SUNDRY NOTICES AND REPORTS ON WELLS

1. OIL WELL ☒ GAS WELL ☐ OTHER ☐		7. UNIT AGREEMENT NAME BIG EDDY UNIT
2. NAME OF OPERATOR MYCO INDUSTRIES, INC.		8. FARM OR LEASE NAME BIG EDDY UNIT ✓
3. ADDRESS OF OPERATOR 207 SOUTH 4th., ARTESIA, NM. 88210		9. WELL NO. 110 ✓
4. LOCATION OF WELL (Report location clearly and in accordance with any State requirements. See also space 17 below.) At surface ✓ 2310' FNL & 330' EEL, SEC. 9 T 22s R 28e.		10. FIELD AND POOL, OR WILDCAT INDIAN DRAW DELAWARE, EAST
14. PERMIT NO.		11. SEC., T., R., M., OR BLK. AND SURVEY OR AREA UNIT H SEC. 9 T 22s R 28e
15. ELEVATIONS (Show whether DF, RT, GR, etc.) 3137 GR.		12. COUNTY OR PARISH EDDY
		13. STATE NM

BIG EDDY UNIT #110

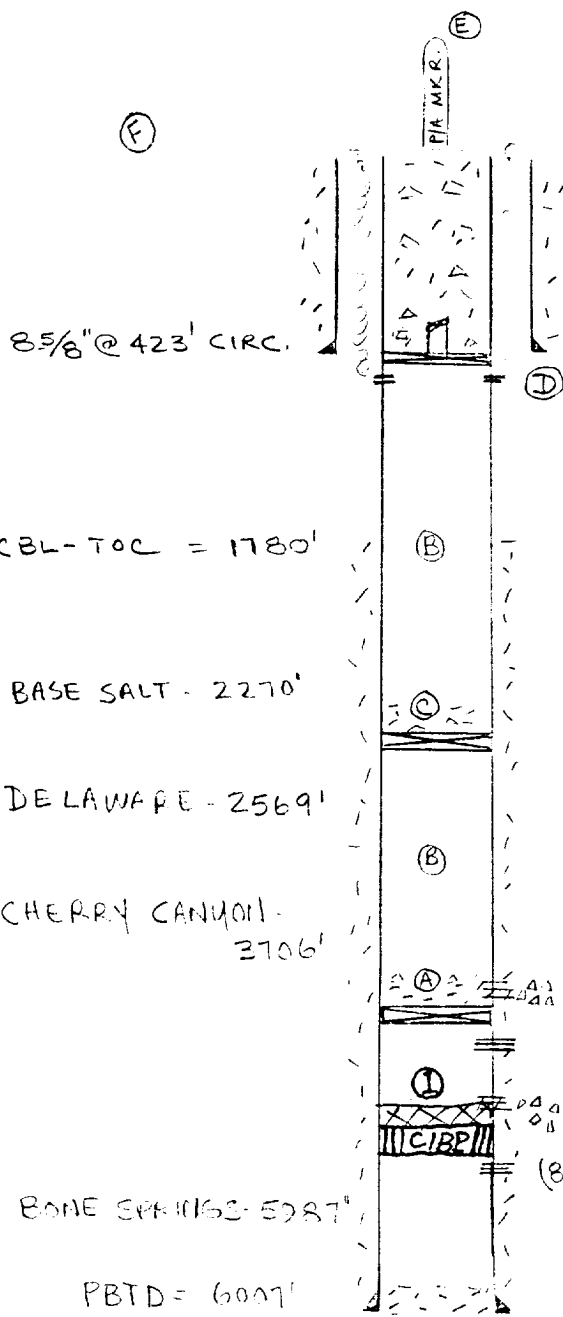
→ SET A CIBP @ 5875' W/15 SACK CMT CAP.

* All changes as per telecon w/ W.A. Gressett, 6/5/91.

- ① CIBP @ 5875' W/15 SXS (35') ^(SXS)
- Ⓐ CIBP @ 4025' W/15-SXS (35')
- Ⓑ LOAD HOLE MUD LADEN FLUID (9.0 lb/gal)
- Ⓒ CIBP @ 2300' W/15-SXS (35') ^(SXS)
- Ⓓ PERF 460'
- CMT SQ RET @ 450'
- * CMT TO SURFACE IN/OUT 5 1/2"
- Ⓔ REGULATION DRY HOLE MRR.
- Ⓕ CLEAN+RE-SEED PER BLM SPECS
- Ⓖ NOTIFY BLM-CARLSBAD 24-HRS PRIOR TO PIA. (887-6544)
